# HISTORIC AND DESIGN REVIEW COMMISSION

May 17, 2017

**HDRC CASE NO:** 2017-180  
**COMMON NAME:** 421-425 E MISTLETOE  
**LEGAL DESCRIPTION:** NCB 863 BLK LOT 14 E 45.5 FT OF 13 & W 4.5 FT OF 15  
**ZONING:** RM-4  
**CITY COUNCIL DIST.:** 1  
**APPLICANT:** Ricardo Turrubiates/Tarramark Urban Homes  
**OWNER:** K/T TX Holdings, LLC  
**TYPE OF WORK:** Construction of housing development

PROTOTYPE 4.2B - FRONT ELEVATION

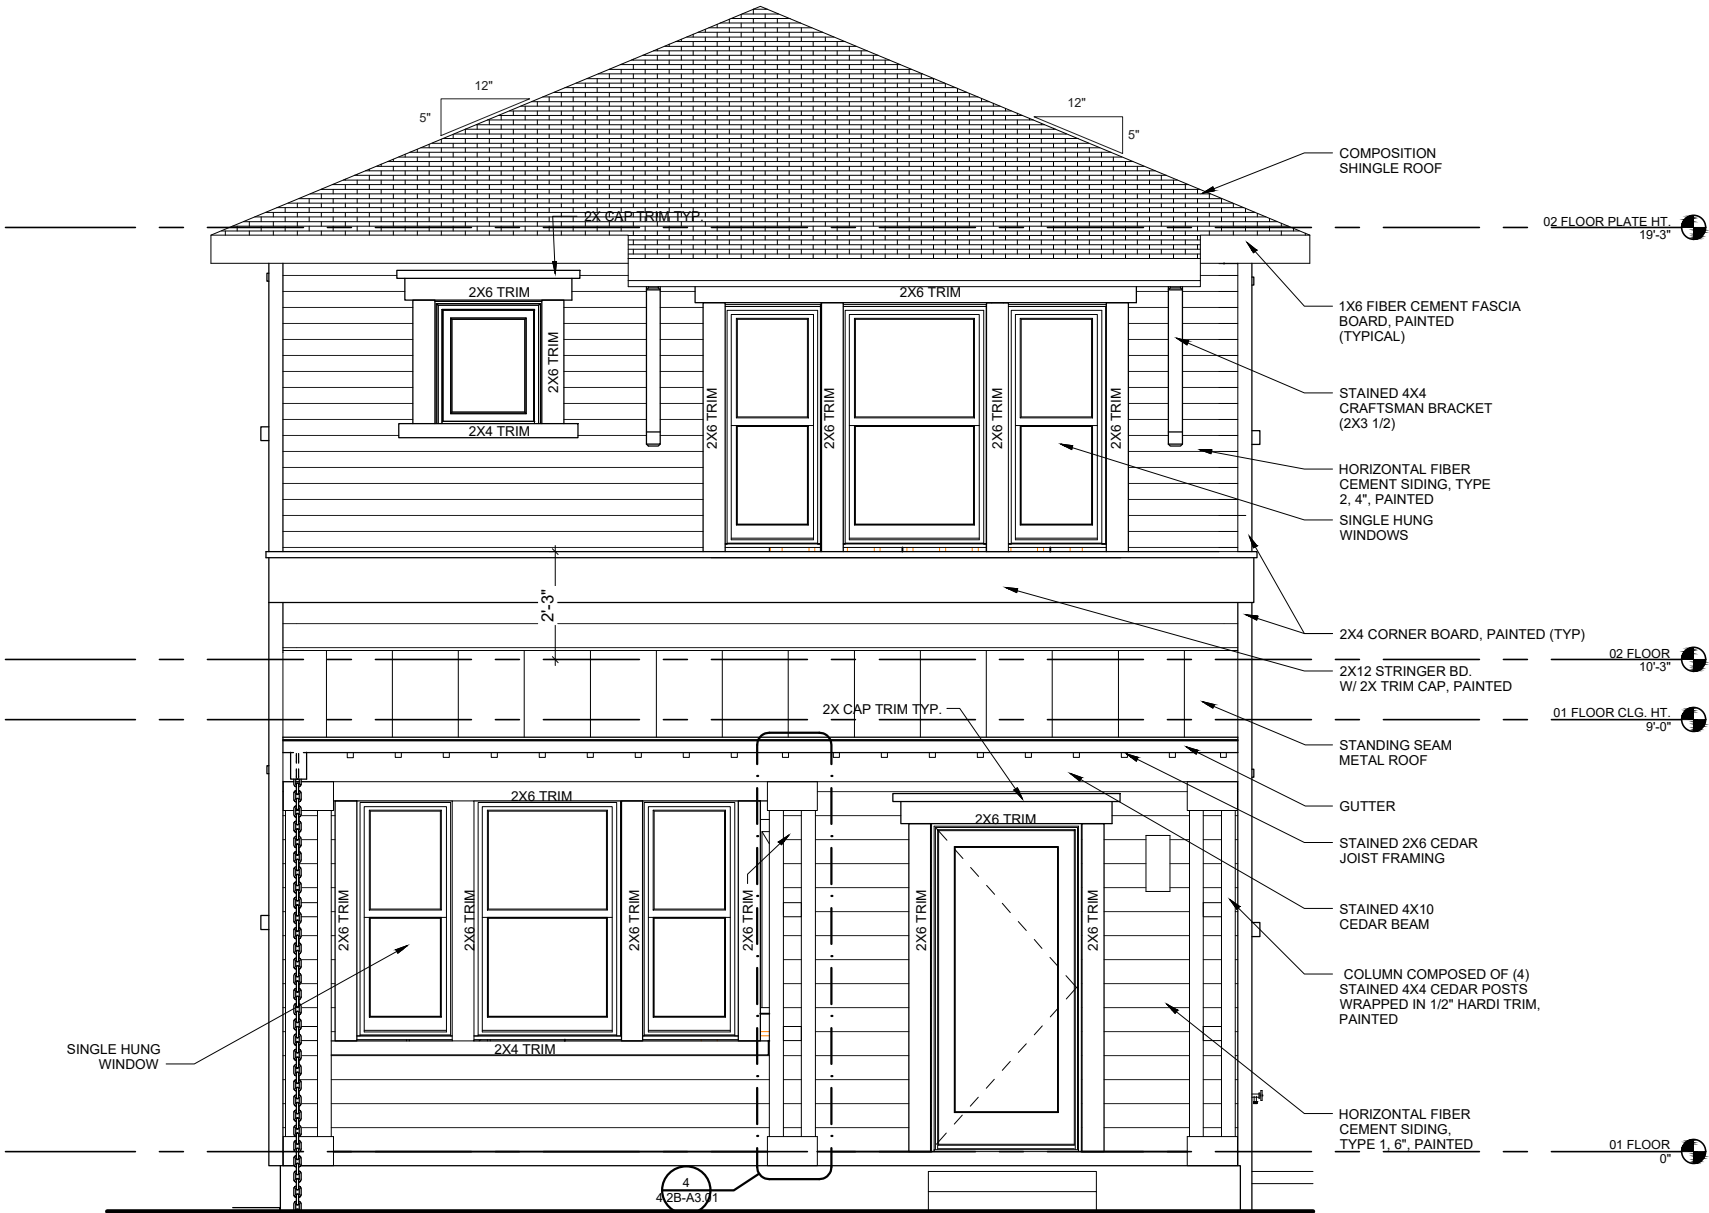
- k. PROTOTYPE 4.2B – This design will be one of the two homes fronting the E Mistletoe streetscape, located at the southeast corner of the lot, as indicated in the submitted site plan. The 2-story house features a composition shingle hipped roof, a standing seam metal roof projecting from the first story to cover the entryway porch, stained 4x4” cedar post columns wrapped in painted hardi trim, and stained 4x4” cedar Craftsman-style brackets beneath the primary roofline. The first story wall material is painted horizontal fiber siding cement with a 6” profile, and the second story wall material is the same material in a 4” profile. A painted horizontal 2x12” stringer with trim cap is located slightly above the interior second floor level. The foundation is approximately 3’ with concrete steps. The height is 19’-3” without the roof height included. Staff finds the proposed porch appropriate for the location of the home along E Mistletoe, as it projects towards the street and contains definitive columns, which mimic the development pattern and residential context of the neighborhood. The house features the 2x2” fixed windows mentioned in finding e as inconsistent with the Historic Design Guidelines, OHP Window Policy document, and historic fenestration patterns of the neighborhood. Additionally, this prototype is a verbatim replica submitted to the March 15 HDRC hearing for the project located at the 600 block of Burleson in Dignowity Hill. This prototype was approved for that particular development.

- a. The applicant explores designs that respond to the context of the district versus utilizing designs that are built or proposed in other parts of the city.
- b. The applicant explores 1.5 story options or prototypes with a modified roof pitch to respond to the dominant historic massing context of the neighborhood.
- c. Fenestration patterns on all prototypes are revised to be more consistent with the size and placement common of historic facades in the district.
- d. That the front porch configuration for Prototype 1436 is modified to include two columns that project from the façade and engage the streetscape.
- e. That the proposed windows are true divided lites or a 1 over 1 configuration with wood screens featuring divided lites to reflect window configurations common in the district and the proposed modern Craftsman approach.

Mistletoe - Building 1

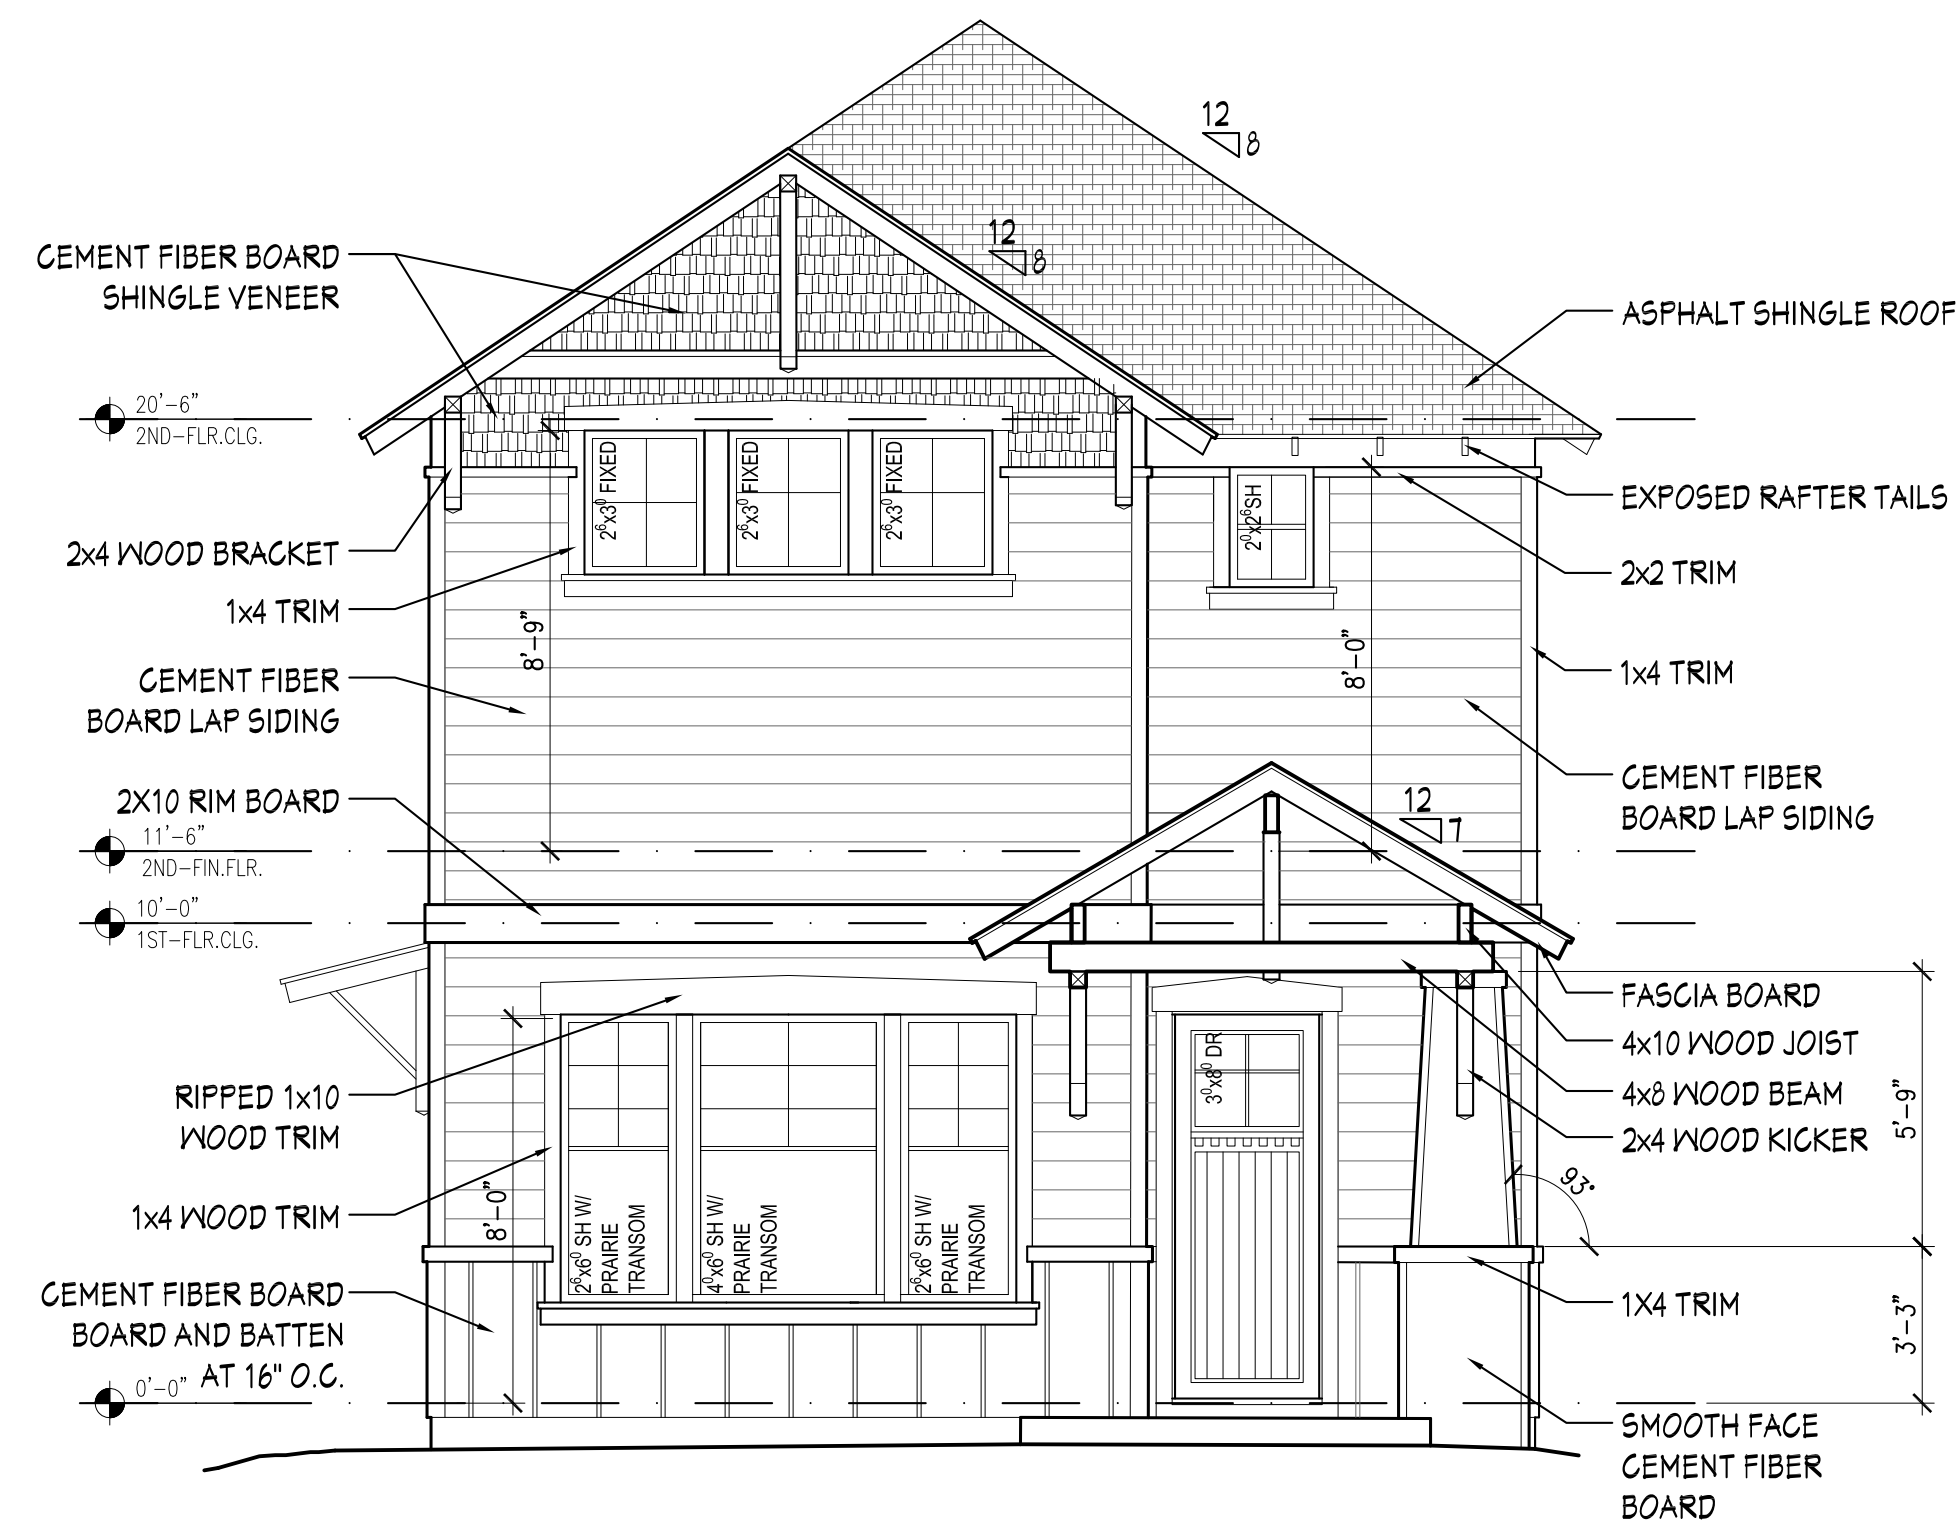
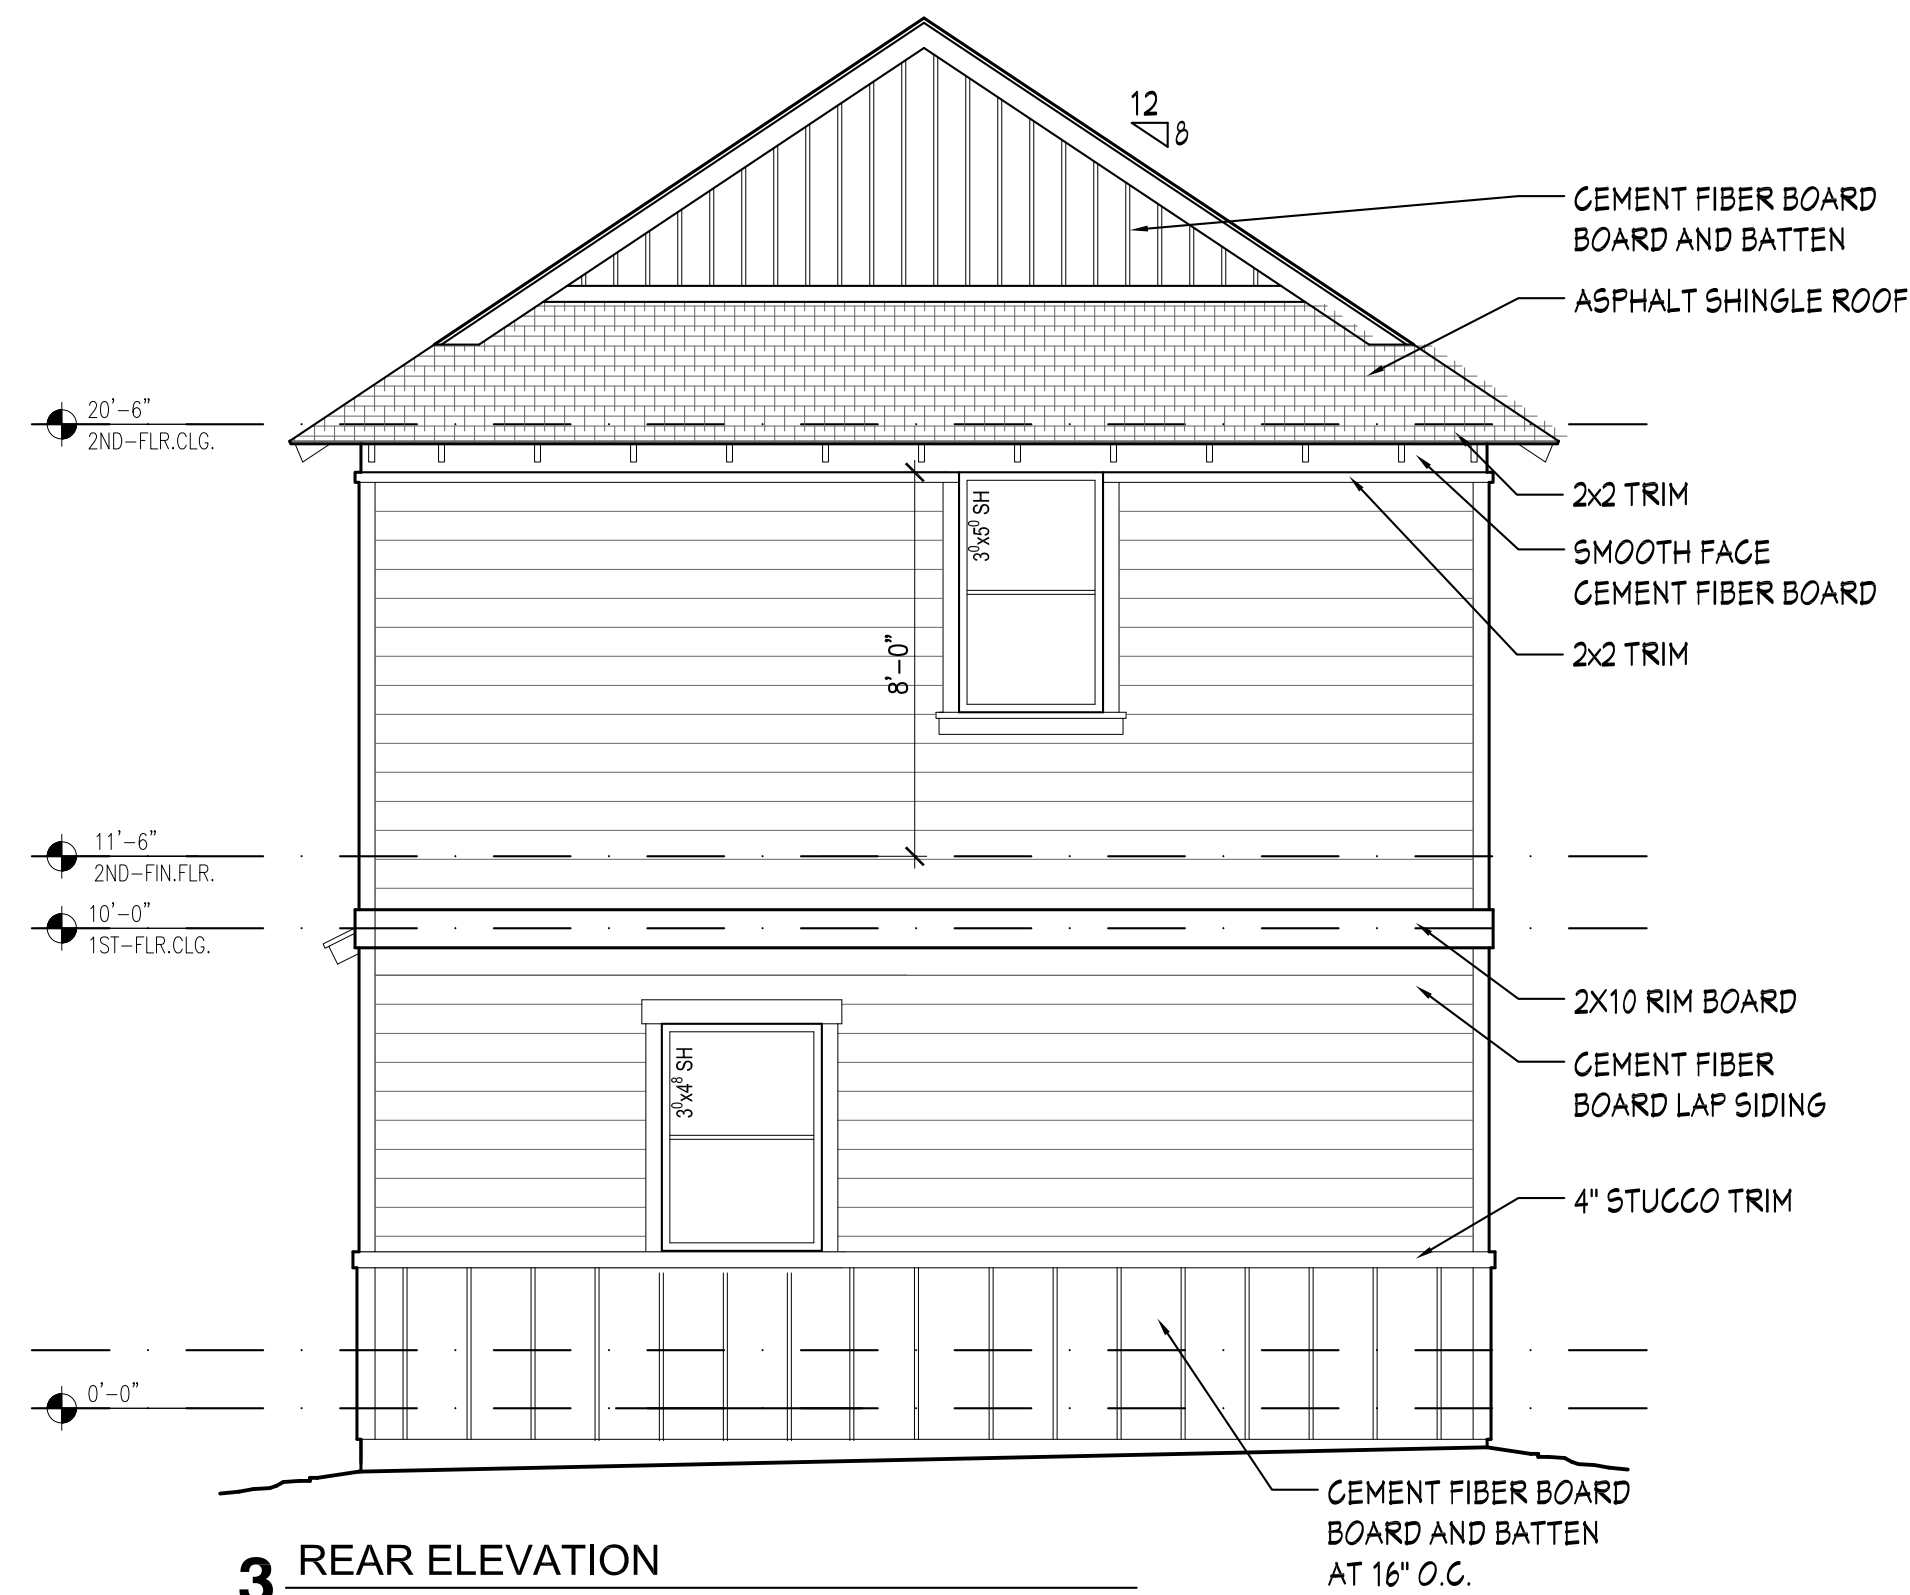
- g. **WINDOW AND DOOR PLACEMENT** – The proposed design for Building 1, Building 2, and Prototype 4.2B include the placement of windows and doors, including their trim, directly abutting rim board, roof trim pieces, and/or fiberboard on every elevation. This direct adjacency of materials and façade elements is not typical of historic approaches to fenestration. Additionally, on some elevations, the blank wall space between openings exceeds the continuous wall space recommendations in the guidelines.

- j. BUILDINGS 1 AND 2 – Building 1 and Building 2 were submitted in the proposal heard by the HDRC on April 19, 2017. In staff recommendations, as well as at the hearing, it was noted that the windows did not comply with the OHP Window Policy document. It was also noted that these buildings did not feature full porches with two columns. The suggested modifications have not been made since the last hearing.
